PUD MINOR MODIFICATION
COMPARISON

1270 4TH ST NE WASHINGTON, DC

MARCH 14, 2016

EAST (4th STREET) ELEVATION

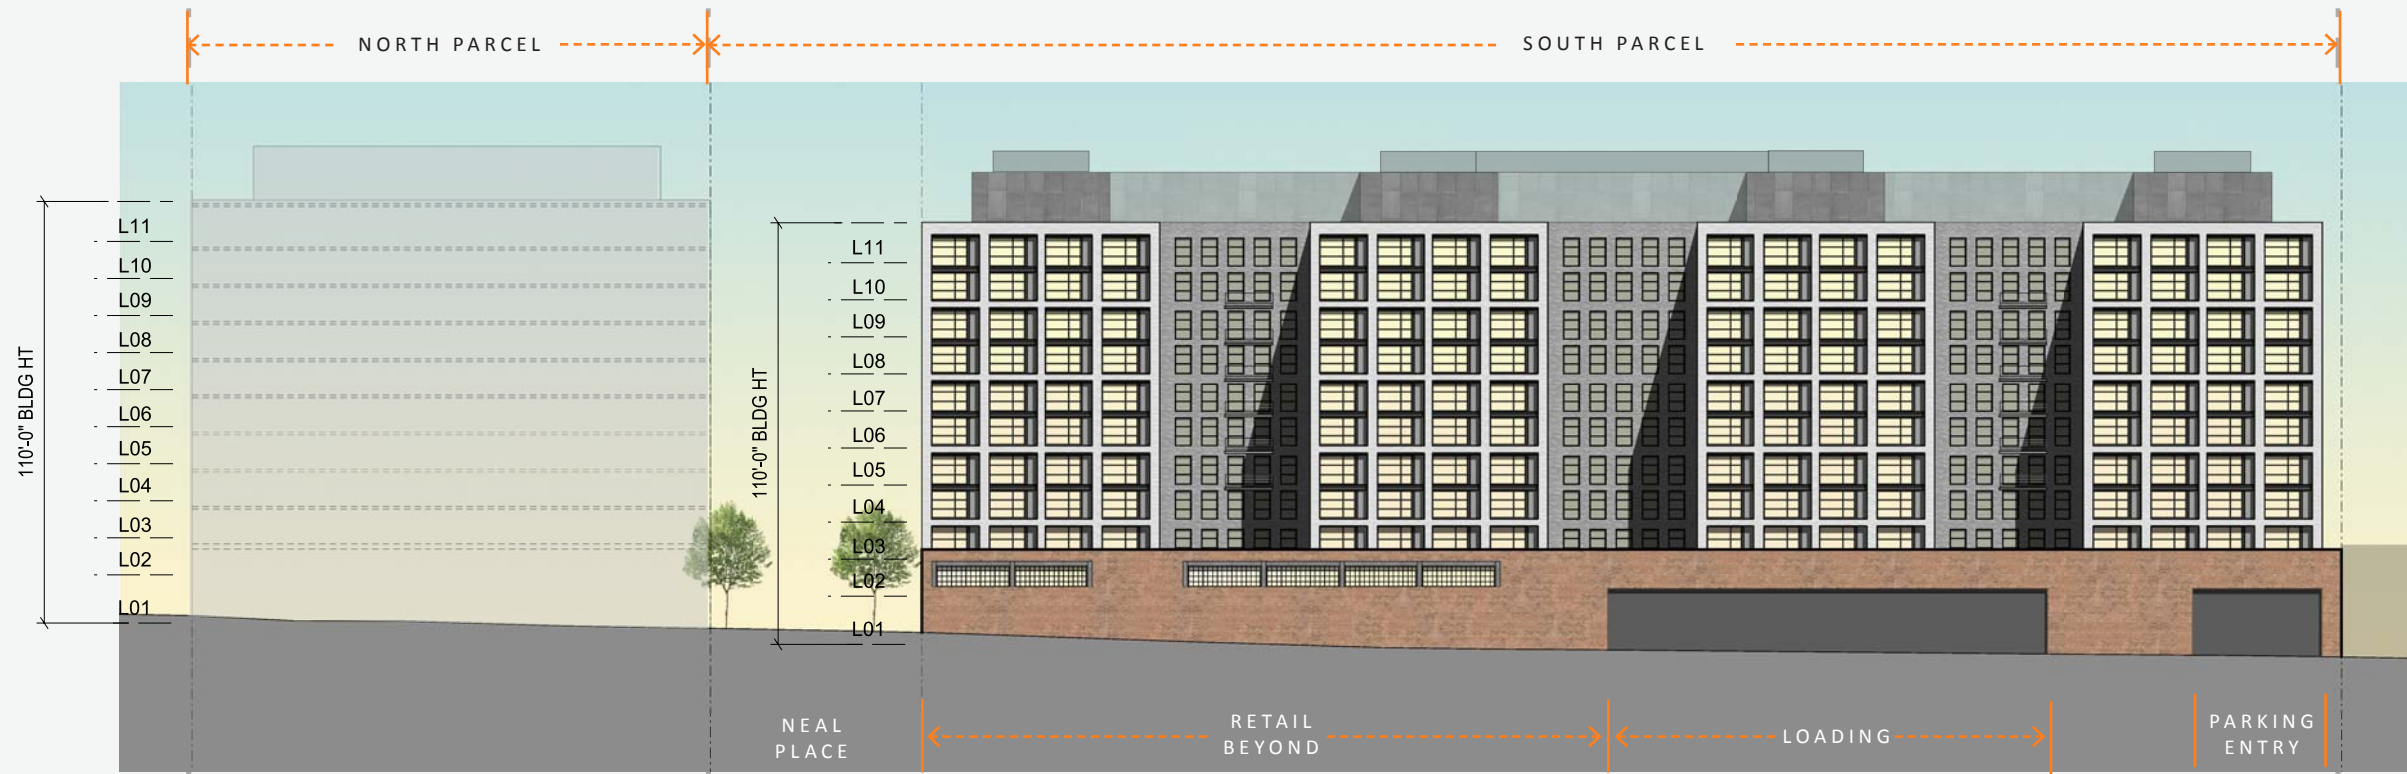
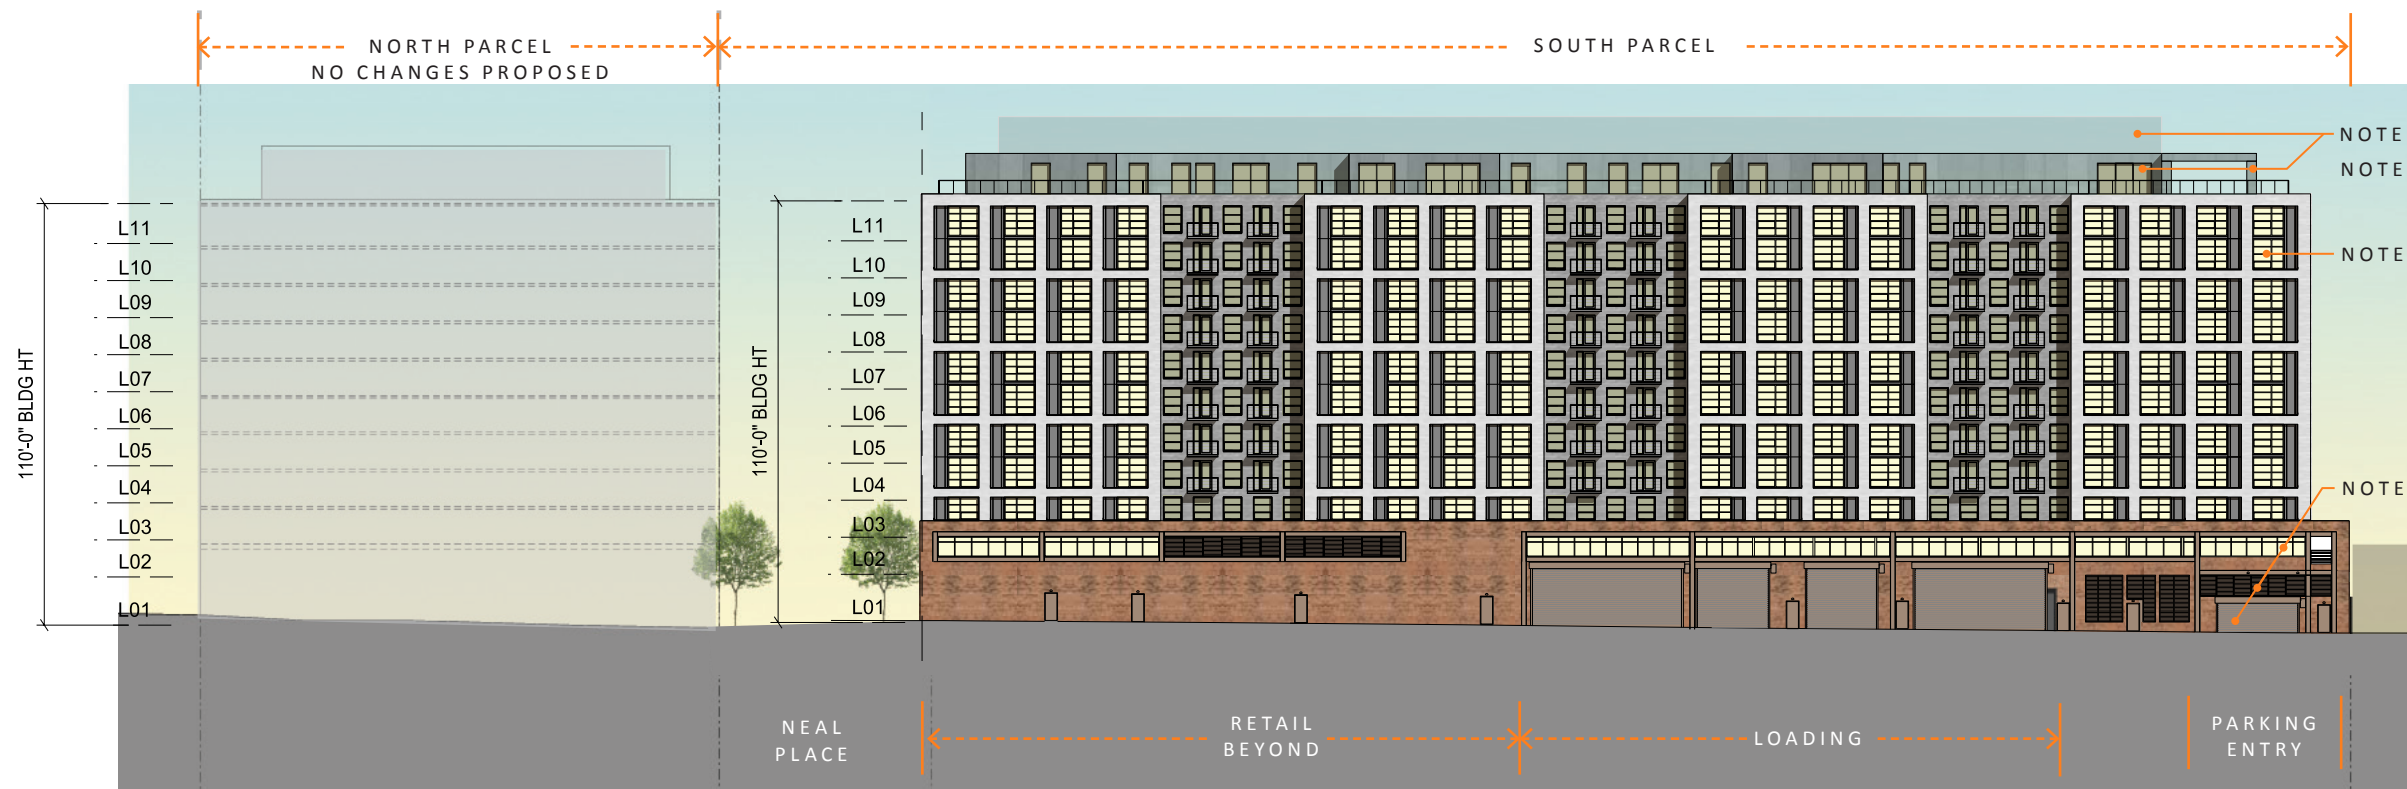
BUILDING FACADE REVISIONS:

- 1 FENESTRATION AND BALCONIES ADJUSTED TO ACCOMMODATE RESIDENTIAL UNIT FUNCTIONS AND UNIT PROGRAM.
- 2 CHANGES AT ROOF STRUCTURE TO INCORPORATE ZC ORDER NO. 14-13:

- PH FOOTPRINT AND PH ROOF SCREEN WALL RECONFIGURED.
- WINDOWS/ DOORS ADDED AT PH LEVEL.
- TRELLIS AT AMENITY SPACE RECONFIGURED.

NOTES: ALL SETBACKS COMPLIANT W/ 1:1 REQUIREMENT.
FACADE REVISIONS CONSISTENT WITH FLEXIBILITY PERMITTED UNDER ORIGINAL ORDER.

WEST (ALLEY) ELEVATION

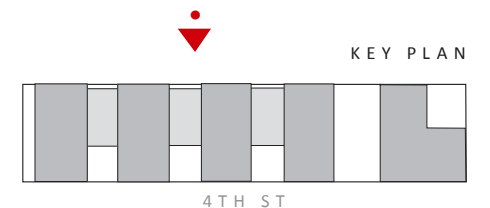
- BUILDING FACADE REVISIONS:**
- 1 FENESTRATION AND BALCONIES ADJUSTED TO ACCOMMODATE RESIDENTIAL UNIT FUNCTIONS AND UNIT PROGRAM.
 - 2 CHANGES AT ROOF STRUCTURE TO INCORPORATE ZC ORDER NO. 14-13:
 - PH FOOTPRINT AND PH ROOF SCREEN WALL RECONFIGURED.
 - WINDOWS/ DOORS ADDED AT PH LEVEL
 - TRELLIS AT AMENITY SPACE RECONFIGURED.
 - 3 GROUND & 2ND FLOOR ELEVATION FENESTRATION, DOORS, LOUVERS CHANGED TO ACCOMMODATE OPERATIONAL REQUIREMENTS AND TO ENLIVEN REAR FACADE.

NOTES: ALL SETBACKS COMPLIANT W/ 1:1 REQUIREMENT.
FACADE REVISIONS CONSISTENT WITH FLEXIBILITY PERMITTED UNDER ORIGINAL ORDER.

CURRENT DESIGN: MAR 14 2016
ENLARGED
EAST ELEVATION

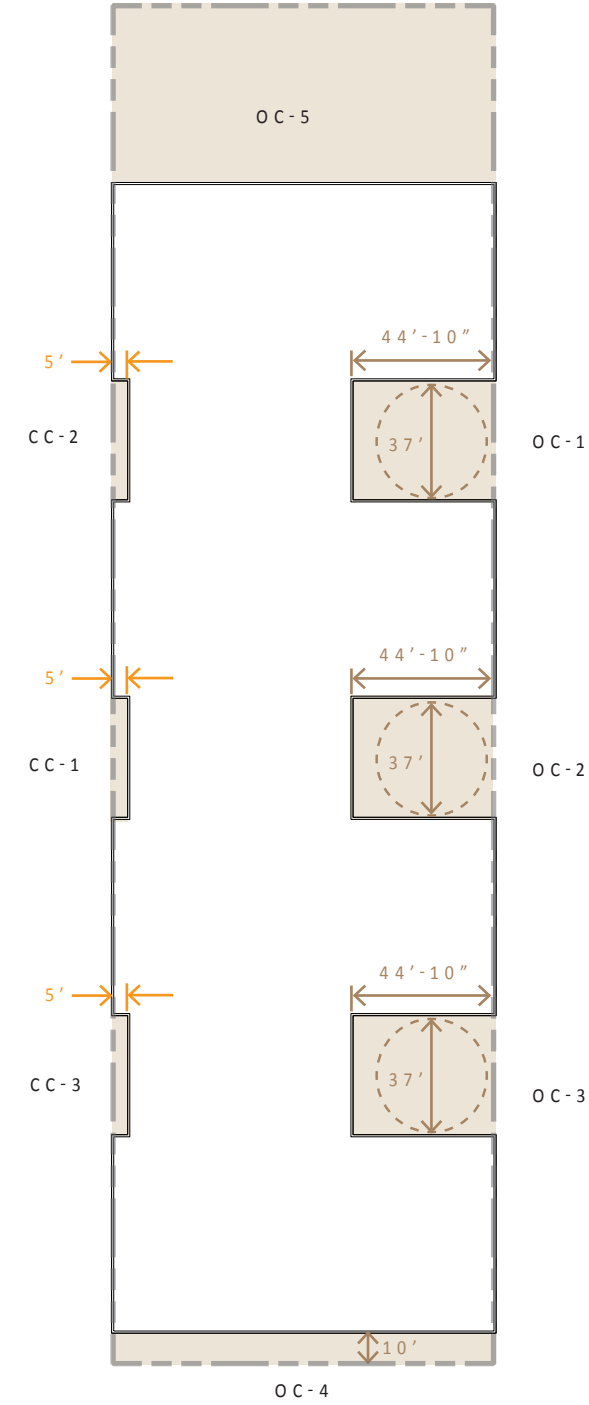
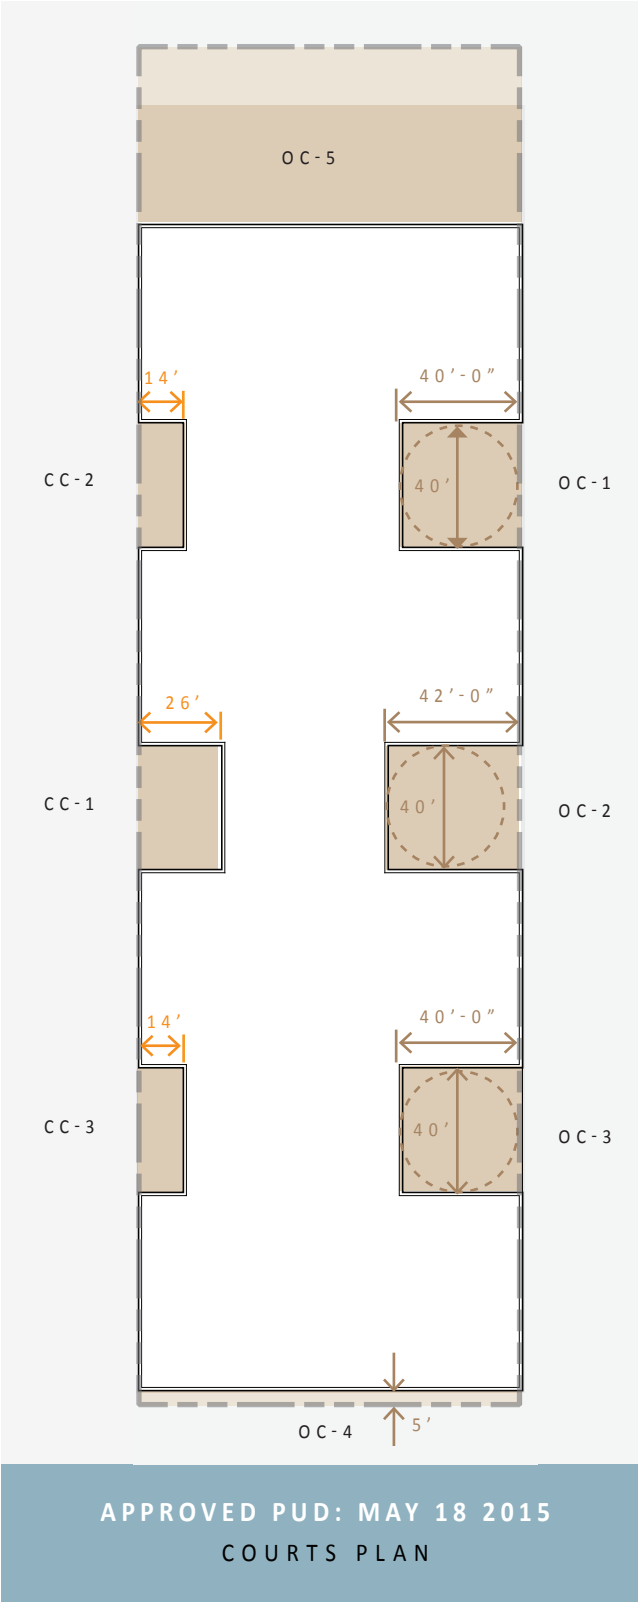
BUILDING FACADE REVISIONS:

FENESTRATION AND BALCONIES
ADJUSTED TO ACCOMMODATE
RESIDENTIAL UNIT FUNCTIONS AND UNIT
PROGRAM.

NOTE: FACADE REVISIONS CONSISTENT WITH FLEXIBILITY PERMITTED UNDER ORIGINAL ORDER.

PENTHOUSE REGULATION REVISIONS

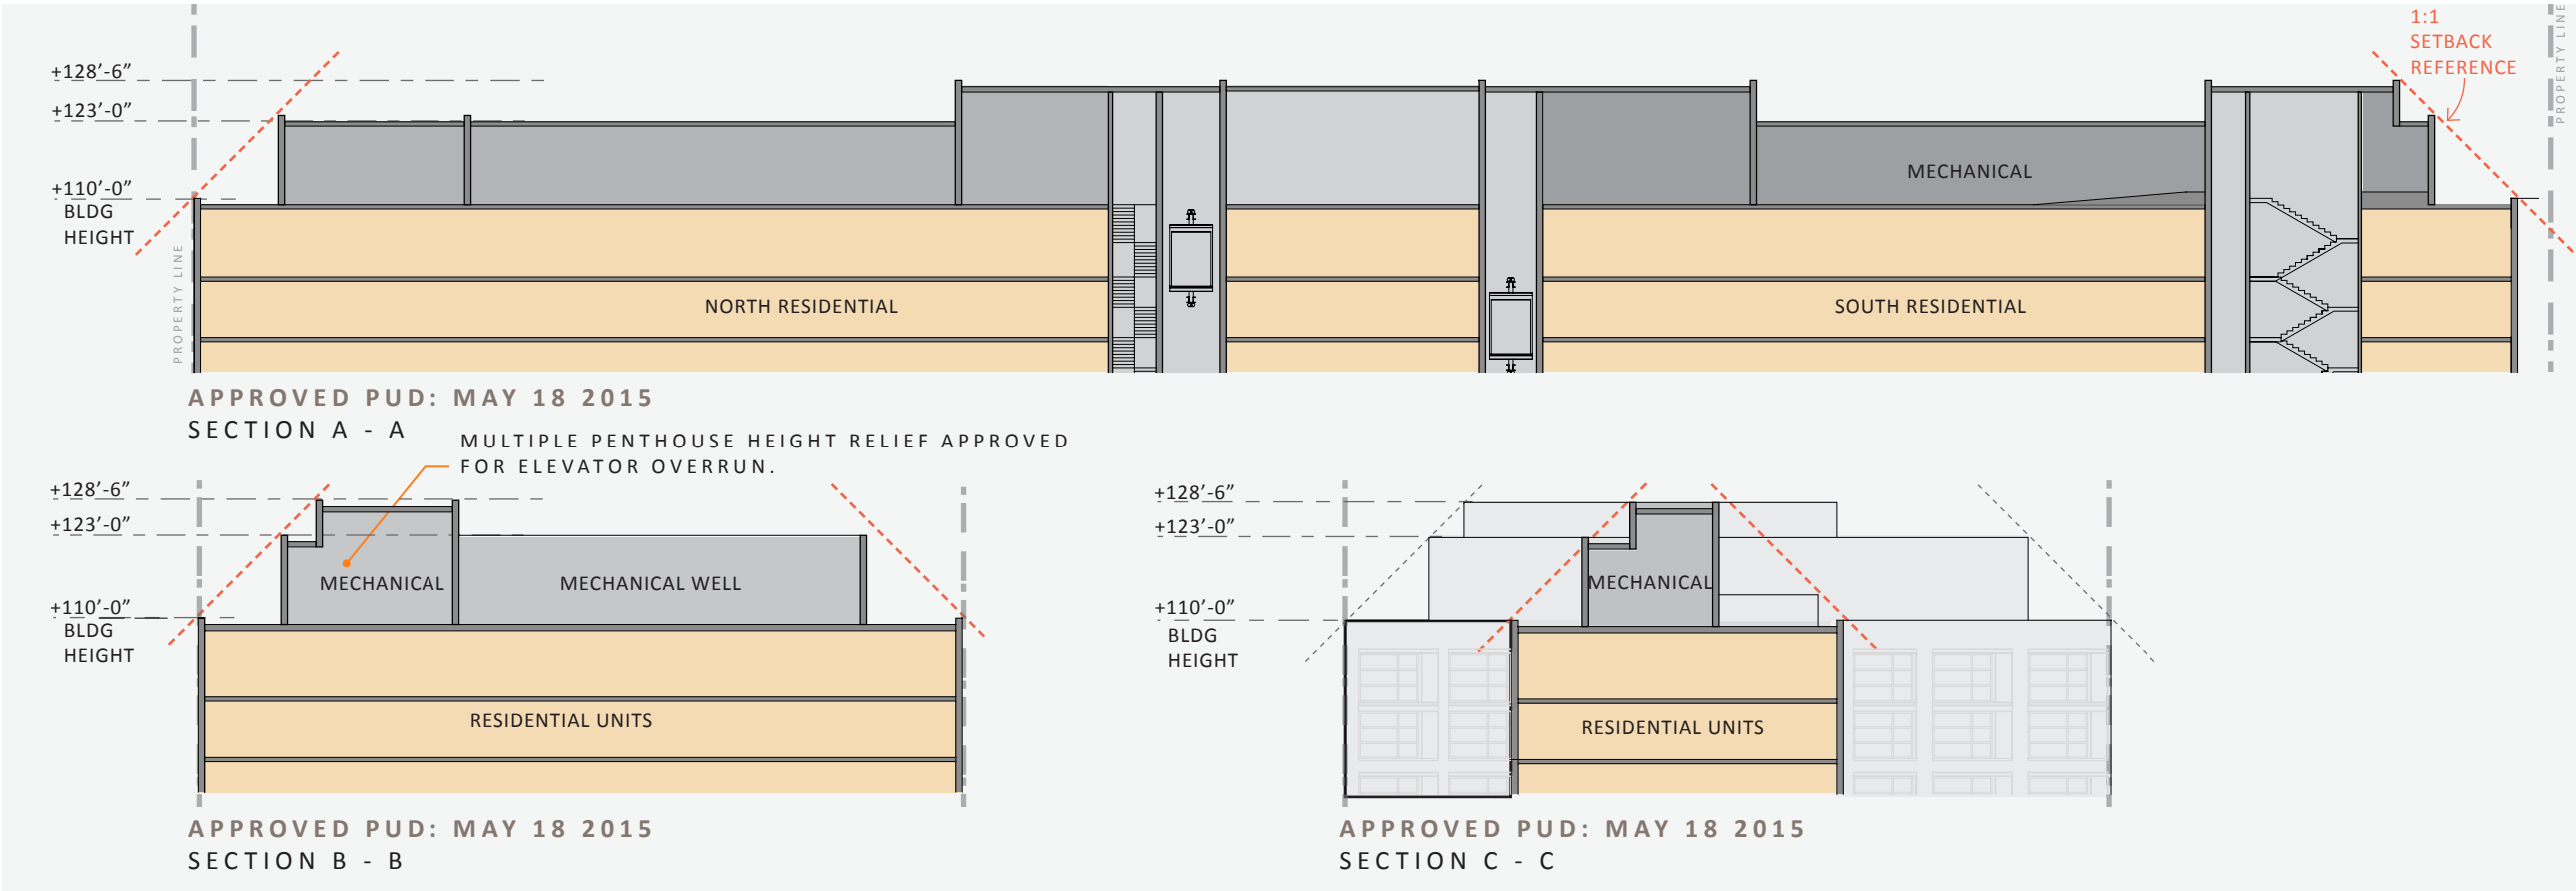
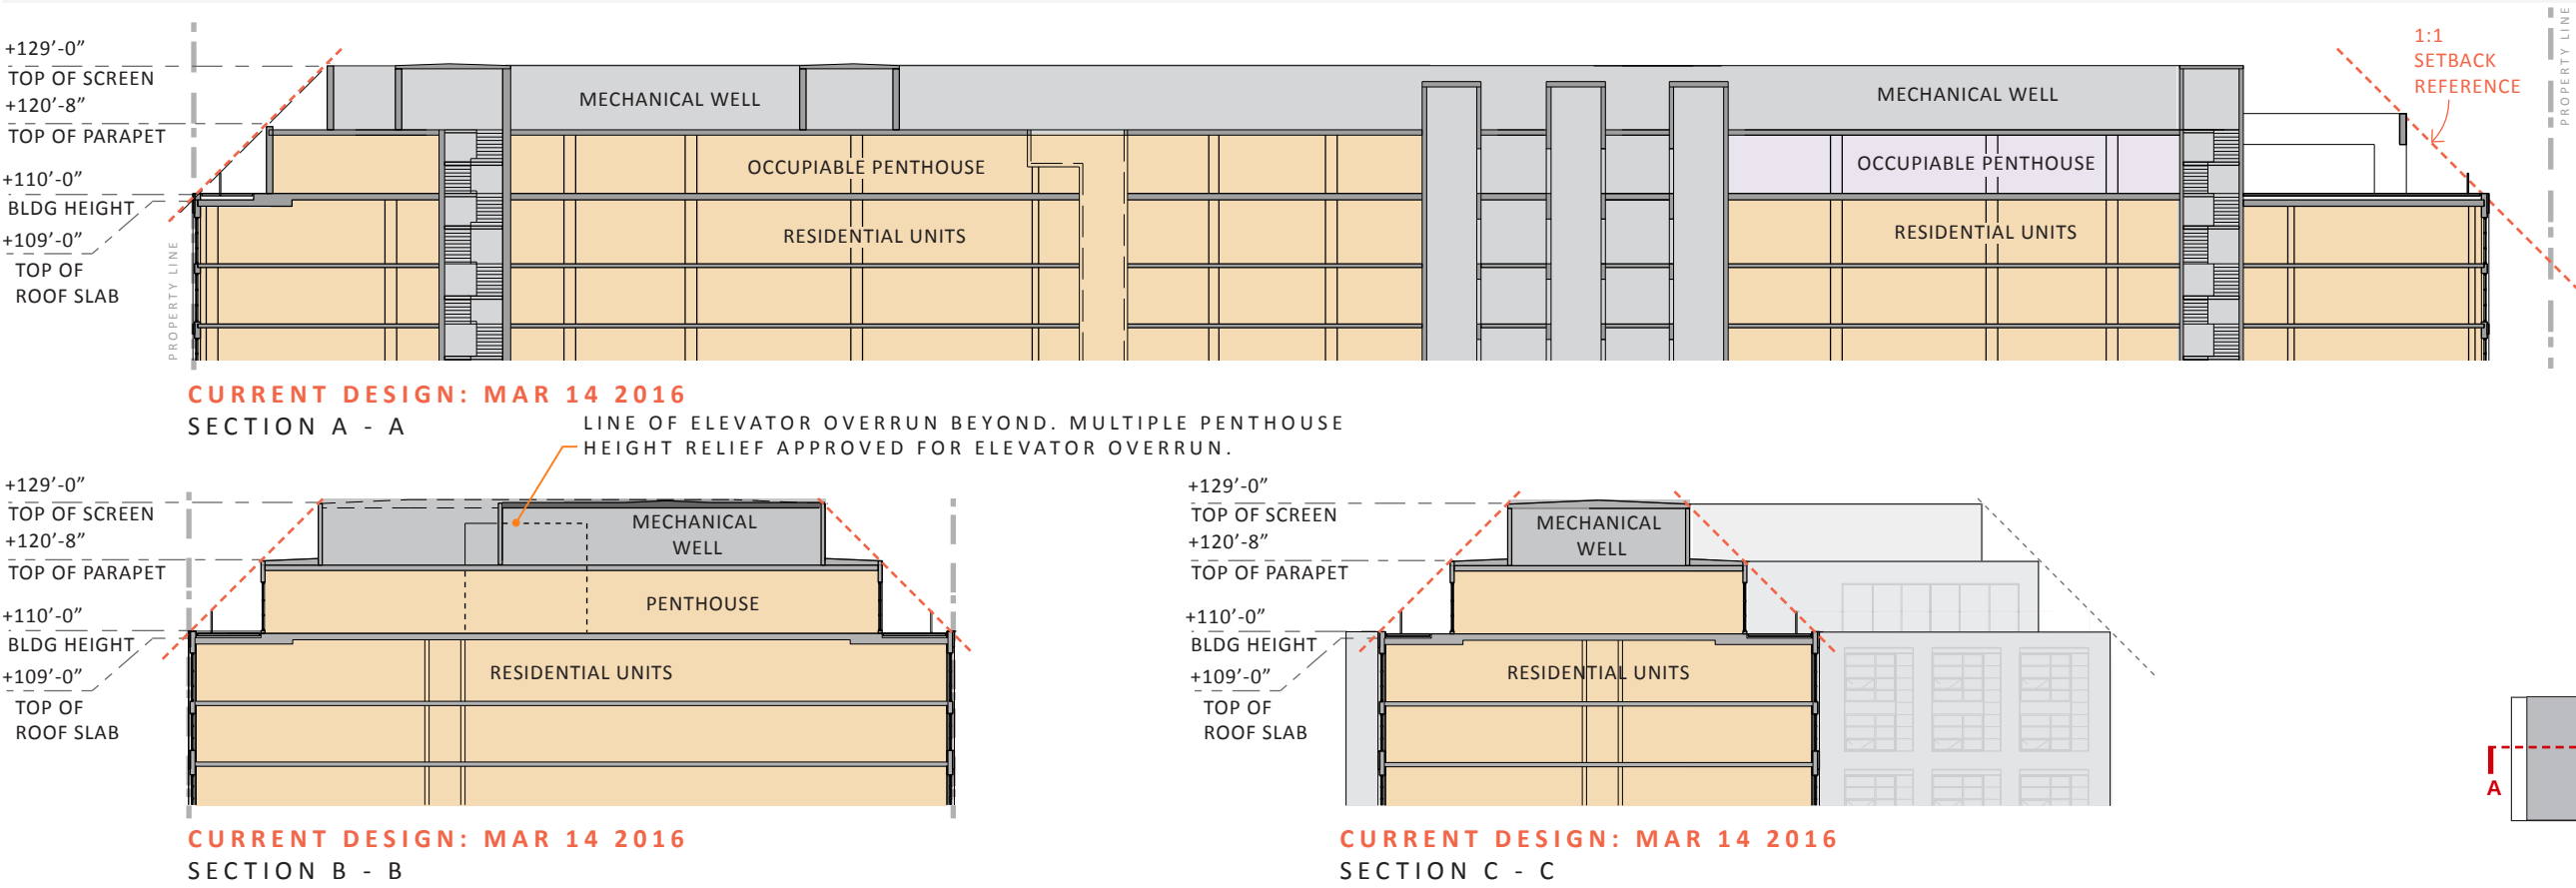
1. CHANGES REQUIRE NO ADDITIONAL RELIEF FROM ZONING REGULATIONS. RELIEF FOR MULTIPLE ROOF STRUCTURE HEIGHTS REMAINS DUE TO HEIGHT OF ELEVATOR OVERRUN IN AREA SHOWN ON DIAGRAM AT LEFT.
